From: [Hogness, Magda](#)
To: [PRC](#)
Subject: FW: Project 3020338
Date: Friday, February 02, 2018 1:55:12 PM
Attachments: [height.png](#)

From: melissa stoker [mailto:melissastoker1@gmail.com]
Sent: Monday, January 29, 2018 8:03 PM
To: Hogness, Magda <Magda.Hogness@seattle.gov>
Subject: Project 3020338

I'm writing this comment letter on behalf of Save Madison Valley. We have spent some time looking over the most recent plan set and have found a number of changes or discrepancies from what was decided at the final Design Recommendation Meeting in September 2017 that we would like to draw to your attention. I have gathered the group's input and listed it here.

2 EAST ELEVATION - NORTH END
SCALE: 1/8" = 1'-0"

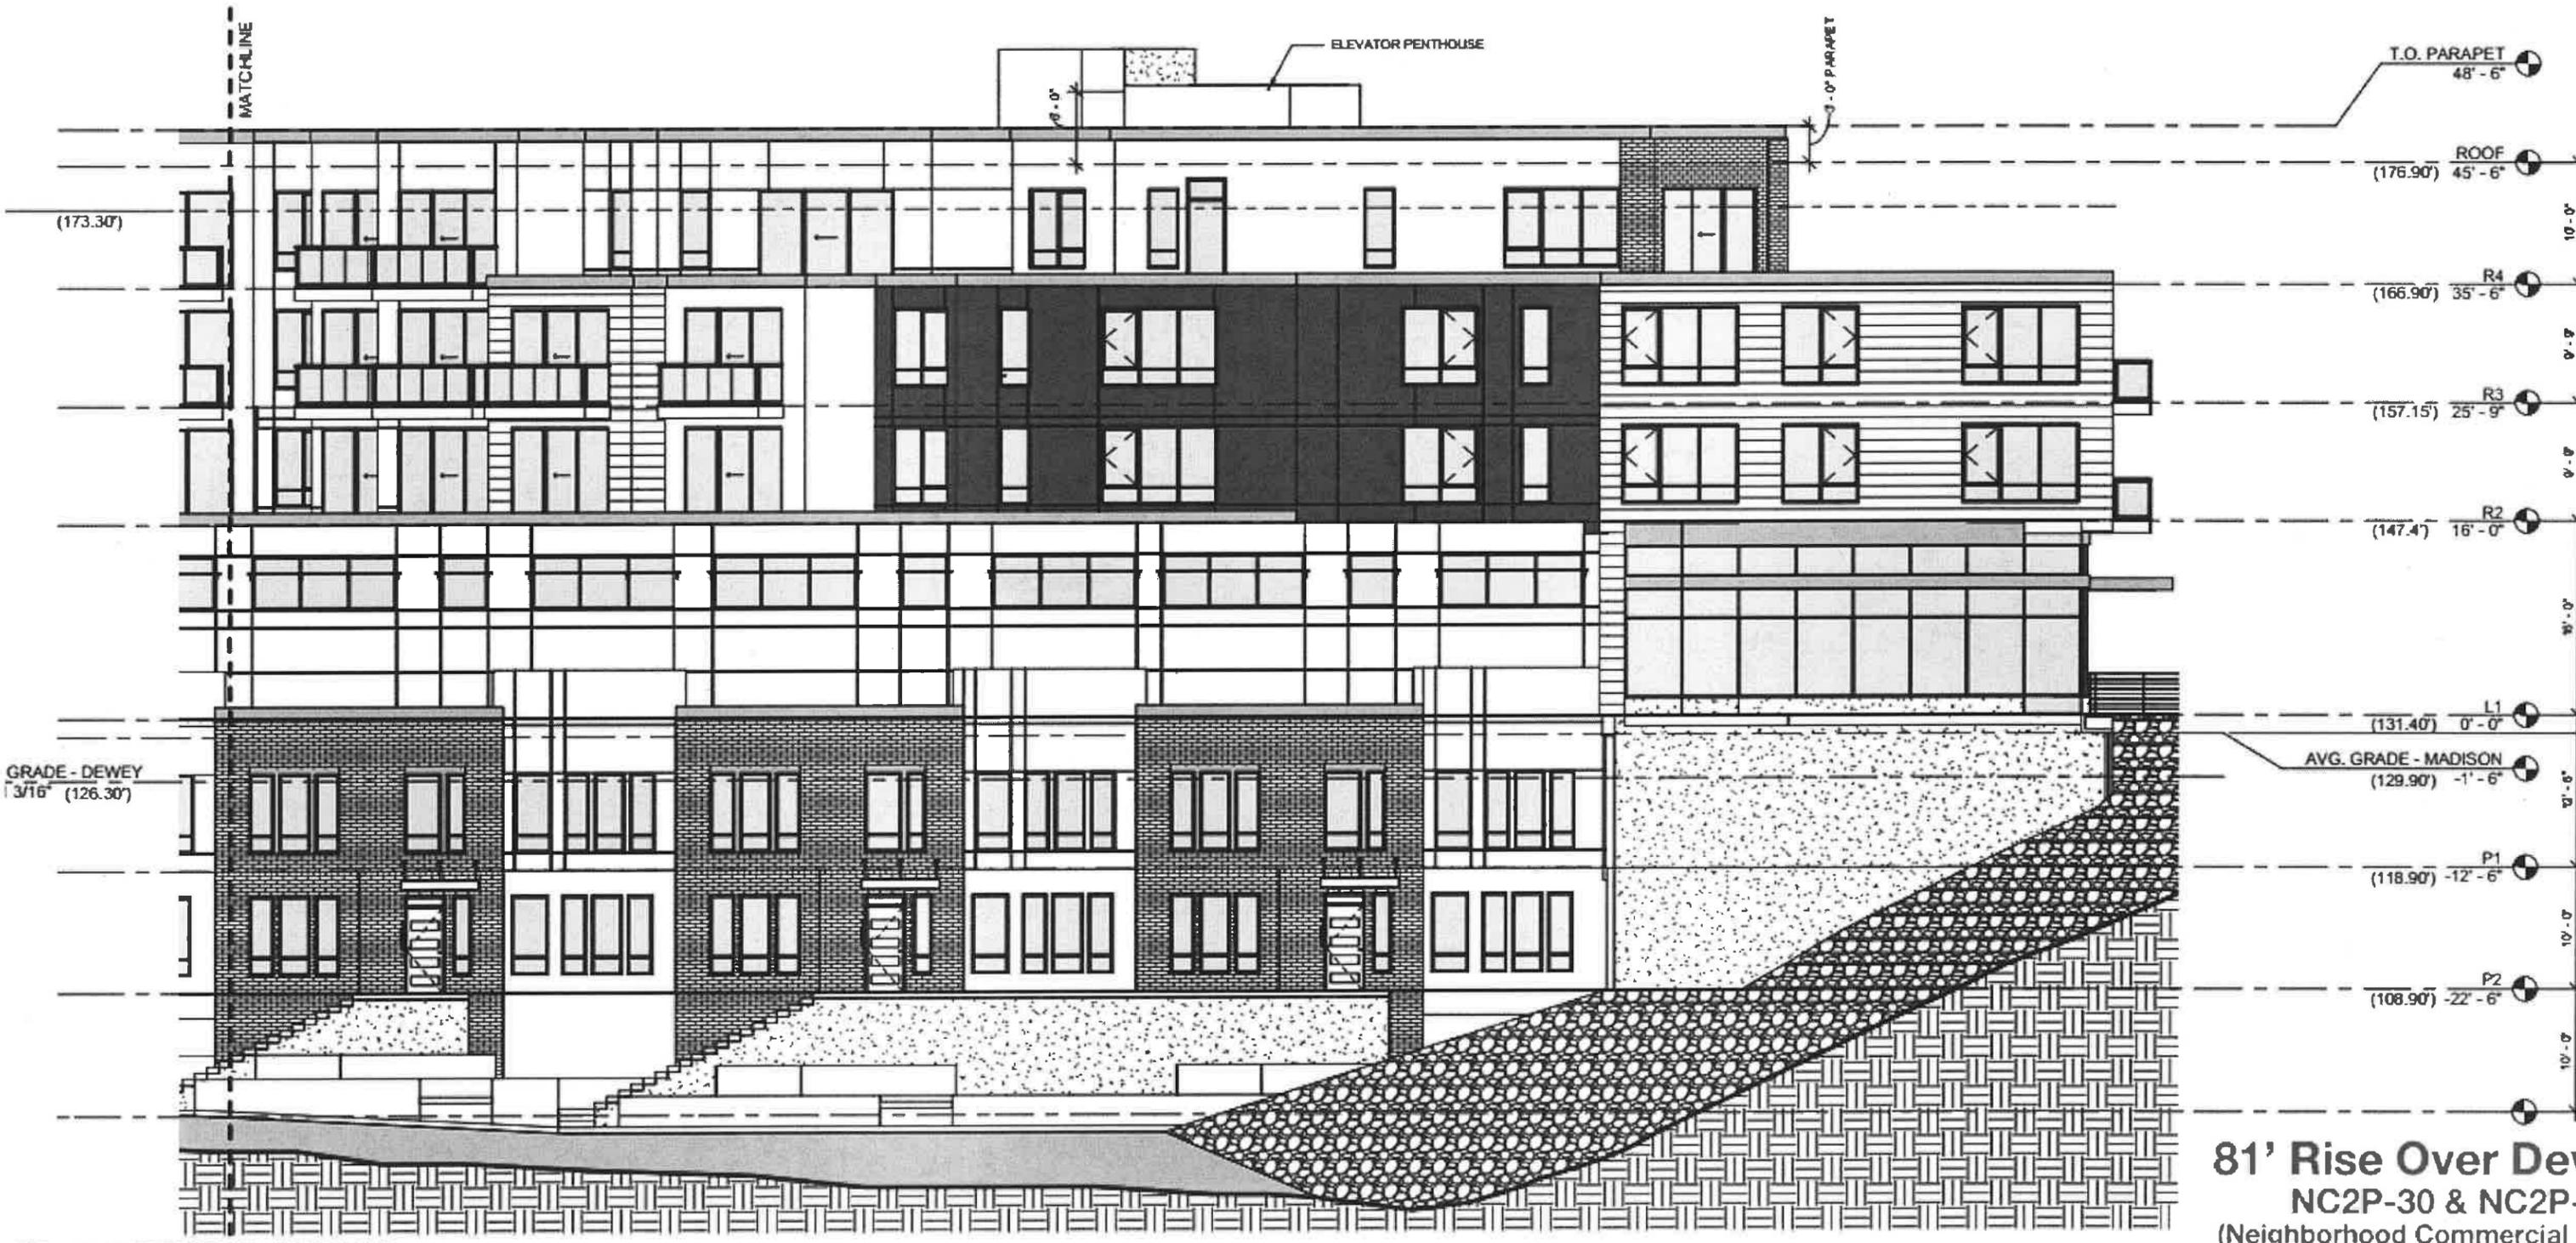
The project has been variously described as a 4-story building, a 6-story building, and a 7-story building. As is shown from the calculations made on the applicants diagram provided in the most recent plan set (attached) the building now rises 81 feet on the east side. In no place has the Design Board approved an 81-foot structure. Please see the attached diagram with our notes.

81' Rise Over Dewey
NC2P-30 & NC2P-30
(Neighborhood Commercial)
